## July inspection report

Permit Number: C-1982-056	County: Routt		
Mine Name: Foidel Creek Mine	Operation Type: Underground		
Operator: Twentymile Coal, LLC	Permit Status: Active		
Operator Address:	Ownership: Private		
Ms. Miranda Kawcak			
29515 Routt County Road No. 27	<b>Operator Representative Present:</b>		
Oak Creek, CO 80467			
	Michael Peterson		
Operator Representative Signature: (Field Issuance Only)

Inspection Start Date: July 8, 20 Inspection Start Time: 11:00 Inspection End Date: July 8, 202 Inspection End Time: 14:00			Inspection Type: Coal Partial Inspection Inspection Reason: Normal I&E Program Weather: Clear	
Joint Inspection Agency:		Joint	<b>Inspection Contacts:</b>	
None				
<b>Post Inspection Agency:</b>		Post	Inspection Contacts:	
None				
Inspector(s):	Inspecto	r's Sig	nature: Signature Date	:
Brock Bowles	Brah	La	ls	
			July 18, 2024

Photo 1 – Cattails are blocking water flow at culvert discharge. Yellow arrow pointing at culvert.

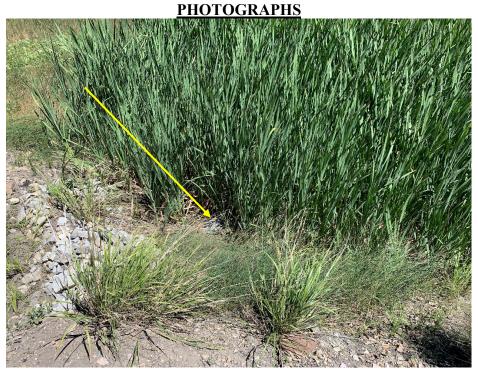
The culvert outlet under the batch weigh loadout road needs to have the cattails cleared (photo 1). The cattails are densely clustered at the end of the culvert, effectively blocking any water flow. This maintenance item was brought up in the June 11, 2024 inspection report and needs to be addressed.
